Well Name: FEDERAL 28	Well Location: T25N / R9W / SEC 28 / NWSW / 36.36896 / -107.80042	County or Parish/State: SAN JUAN / NM
Well Number: 2E	Type of Well: CONVENTIONAL GAS WELL	Allottee or Tribe Name:
Lease Number: NMSF078309	Unit or CA Name:	Unit or CA Number:
US Well Number: 300452620500C1	Well Status: Producing Gas Well	Operator: EPIC ENERGY LLC

Type of Submission: Notice of Intent	Type of Action: Plug and Abandonment
Date Sundry Submitted: 07/08/2021	Time Sundry Submitted: 02:35
Date proposed operation will begin: 07/09/2021

**P&A Procedure****EPIC Energy – Federal 28 2E**

# BLM FLUID MINERALS P&A Geologic Report

Proposed P&A

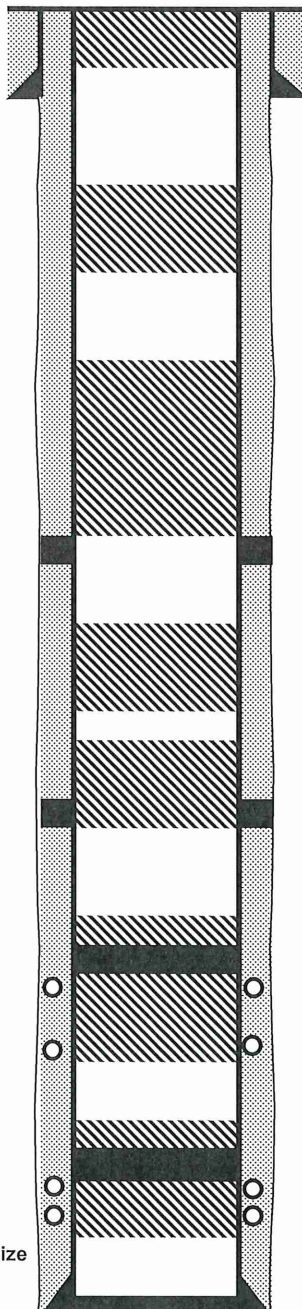
- No CBL on file, recommend running CBL prior to pumping any plugs.
- Please add an inside plug from 2194' – 2344' to cover the Chacra top @ 2294'.
- Please add an inside plug from 1536' – 1686' to cover the Fruitland top @ 1636'.
- Bring the bottom of Plug #7 (Surface) down to 310' to cover 50' below the Surface shoe @ 260'.
- The plugs proposed in the P&A procedure, with changes recommended above, will adequately protect any freshwater sands in this well bore.
- Dakota perfs @ 6388' – 6412'. Gallup perfs @ 5366' – 5634'.
